2.1.1 AMENDMENT 1: CPW

Flue heights increased

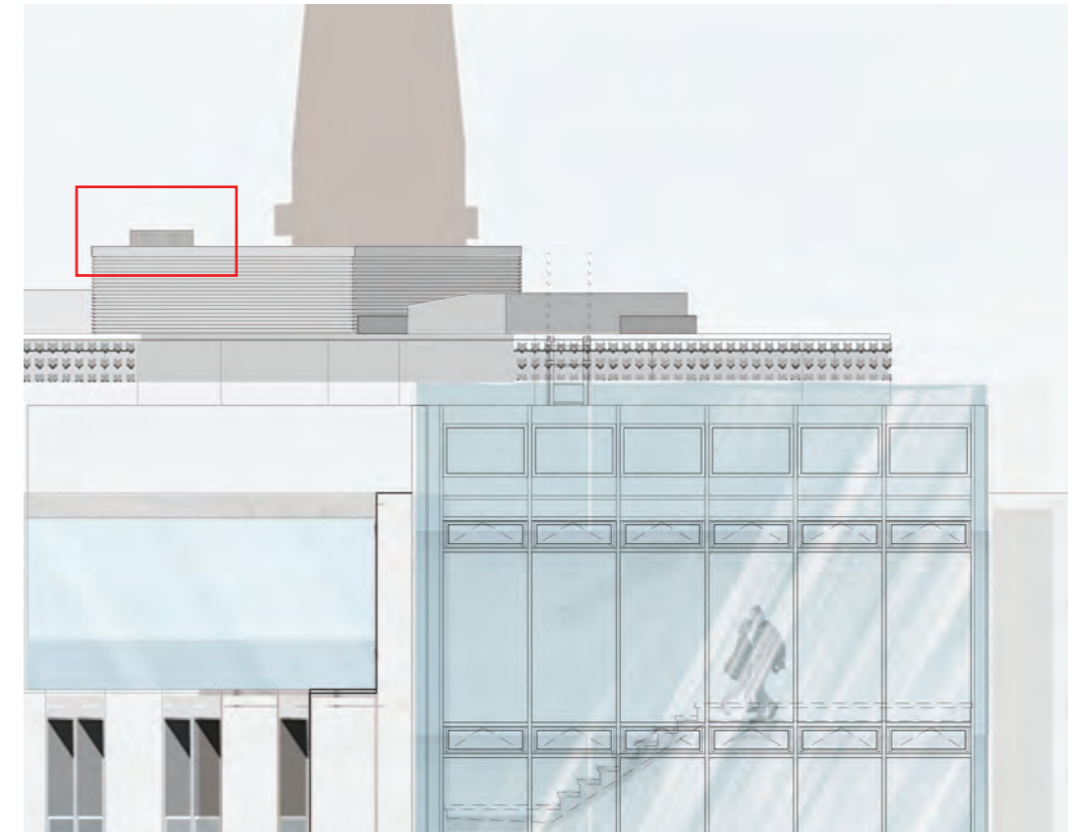
There are currently 2no gas boiler flues and 1no life safety generator flue incorporated in the permitted scheme. It was originally envisaged that these would be concealed within the louvred vent housing to the CPW level 09 roof. However, subsequent discussions have clarified that, in order to satisfy Building Control and Environmental Health requirements for discharge flue termination, the flues need to project a suitable distance above any surrounding structure. This ensures safe, unobstructed evacuation of exhaust gases.

Therefore it is proposed they will now penetrate the roof housing and terminate 215mm above the housing i.e. +59.783 AOD. Previously they were enclosed within the height of the housing. We believe the visual impact from street level to be minimal.
